Service Bulletin

SAFETY RECALL

2002-2003 GL1800/A Frame Weld

Welding Overview

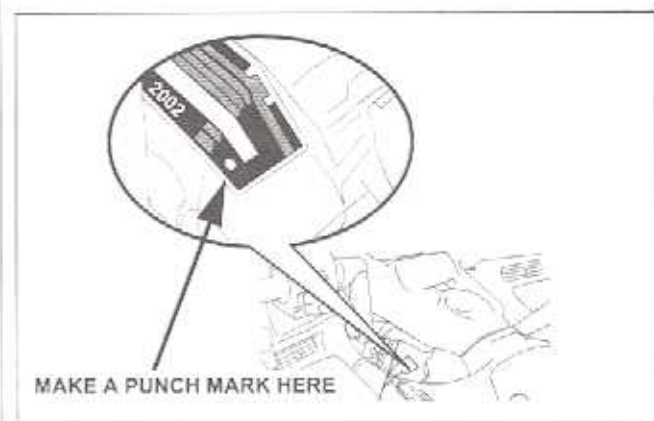
The repair procedure consists of adding additional TIG welding to the frame where the lower cross member joins the side rails.

A qualified TIG welder will weld the frame following the procedures in the *2002-2003 GL1800/A Frame Weld Safety Recall Welding Manual*.
